December 24, 1998

Refer to: HNG-14

In your November 5 letter to Mr. Henry Rentz, you requested the Federal Highway Administration's (FHWA) acceptance of the Eccentric Loader Terminal (ELT) as an National Cooperative Highway Research Program (NCHRP) Report 350 Test Level 3 (TL-3) terminal for W-beam guardrail. To support your request, you also sent copies of a Texas Transportation Institute report, "Crash Testing and Evaluation of the Eccentric Loader Terminal (ELT)," by Mak, Bligh, and Menges, dated October 1998.

STATE OF MINNESOTA
 DEPARTMENT OF TRANSPORTATION
**ECCENTRIC LOADER
 BREAKAWAY CABLE TERMINAL (ELT)**

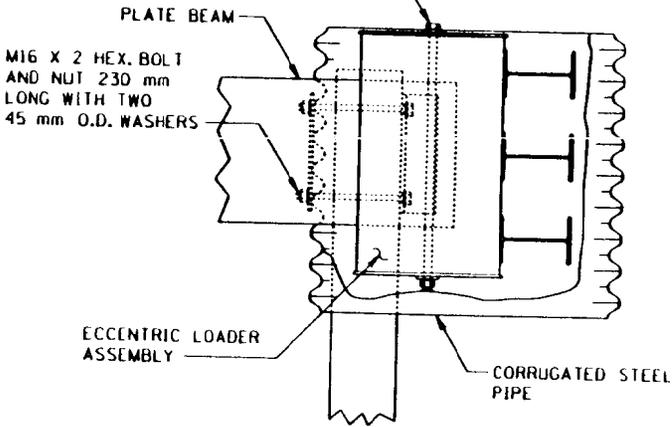
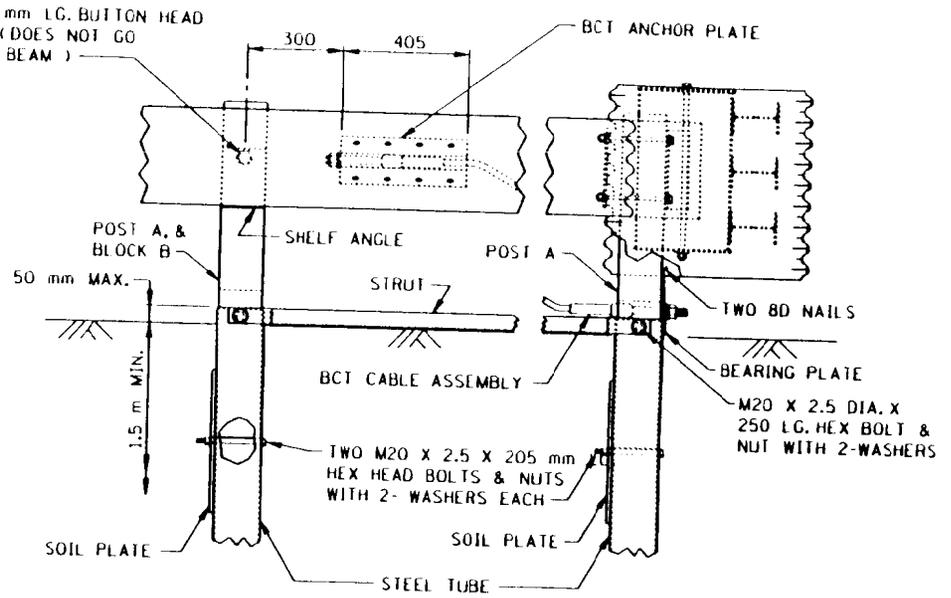
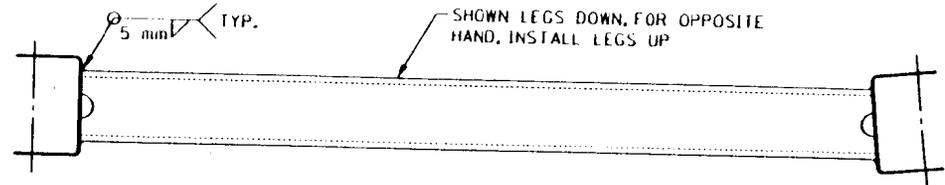
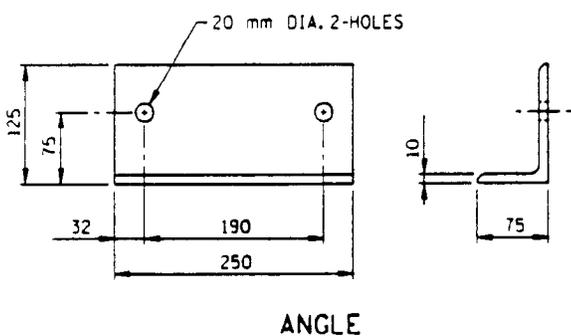
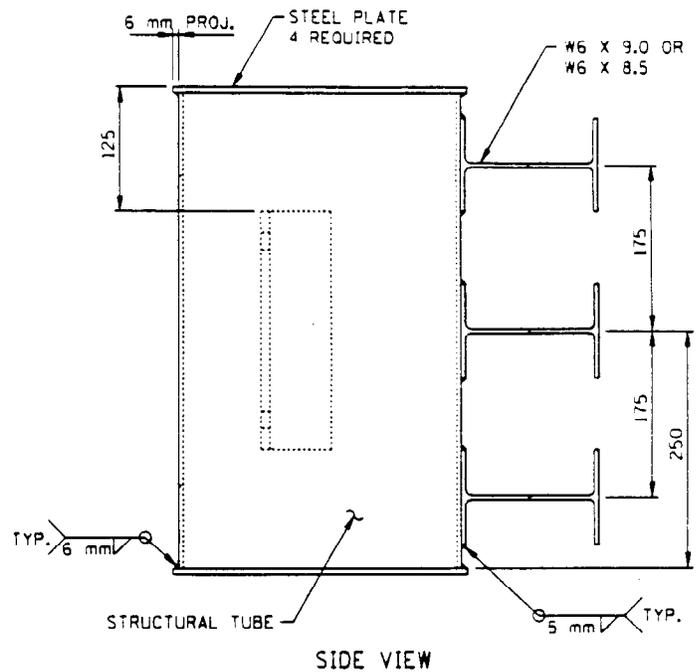
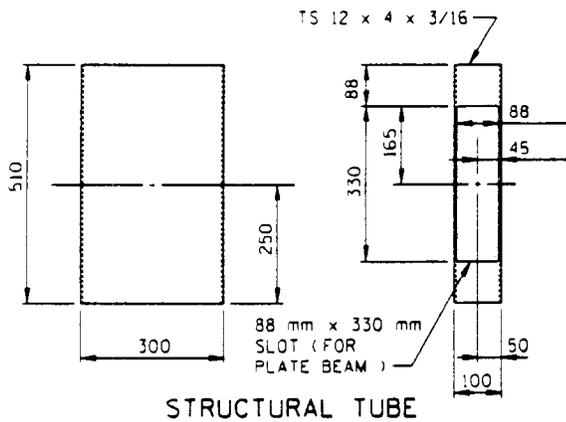
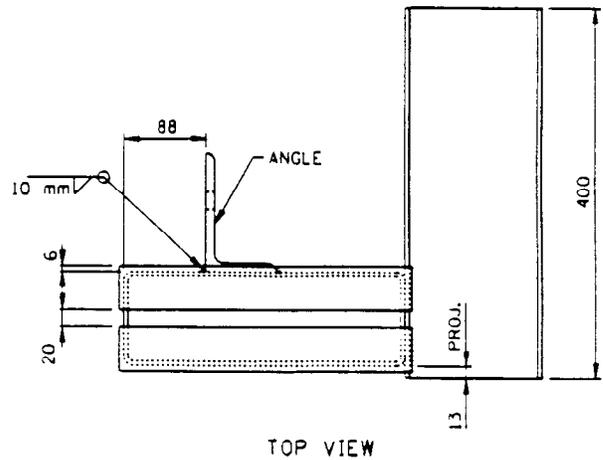
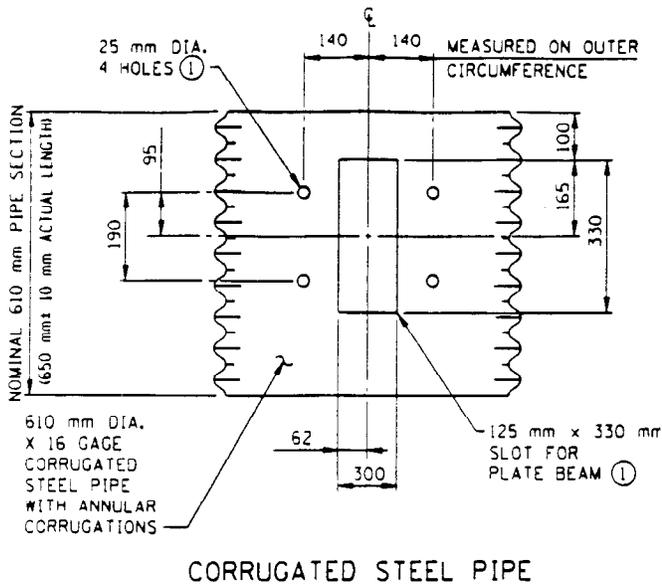
Our review indicated that the ELT that was tested to the NCHRP Report 350 criteria is essentially the same design as the ELT that was developed and tested in the late 1980's under NCHRP Report 230 criteria. The only changes made were the replacement of post number 7 (originally a standard line post) with a fifth wooden CRT post, and a 25 mm extension in the offset distance (from 635 mm to 660 mm) at post number 2. The latter change is reflected in the enclosed drawings (Enclosure 1), and we suggest that the drawings be updated to show clearly the use of CRT posts at post locations 3 through 7.

Finally, we wish to emphasize the necessity and importance of the grading around the terminal that is shown in your standard drawing. As with all gating terminals, impacting vehicles may travel some distance behind and beyond the ELT in an end-on hit so this area needs to be clear of hazards and relatively traversable. You may also wish to revise your standard drawing to show appropriate reflectorization on the nose of the ELT and, as noted above, to show that posts 3 through 7 are CRT posts and post 8 and all downstream posts must be standard timber line posts.
